# SERVICE BULLETIN

SB No. 94 Issue No. 1

**TITLE** INSPECTION OF ELEVATOR PUSHROD TO CONTROL COLUMN ASSEMBLY  
PIVOT BOLT TO SEAT CLEARANCE

T67M260-T3A Pre Mod M695 aircraft.

FIG 1  
VIEW LOOKING FORWARD

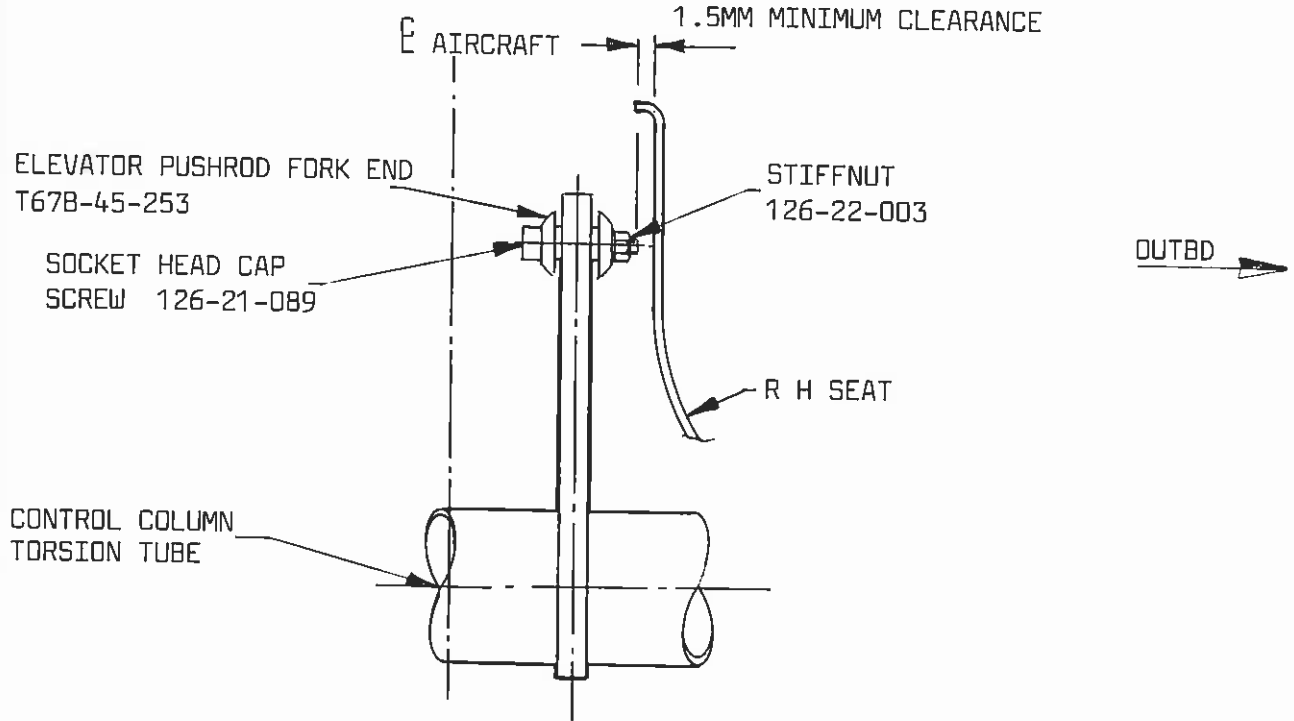
A case has been reported of the elevator pushrod to control column assy pivot bolt tail, rubbing the right hand seat.

1. Compliance A: Check if bolt is rubbing, if so proceed as per paragraph 4.
2. Compliance B: Remove centre console and check bolt tail or bolt head to seat side clearance Ref Fig. 1. Clearance to be a minimum of 1.5mm.
3. If clearance is 1.5mm or more, annotate logbook SB 94 complied with.
4. If clearance is less than 1.5mm then proceed as follows:
  - i. Remove right hand seat.
  - ii. Remove bolt.
  - iii. Obtain new bolt 126-21-211 and assemble with head to R.H. side, Ref Fig. 2.
  - iv. Reassemble seat and console.
  - v. Annotate in logbook SB 94 complied with and Mod M695 incorporated.
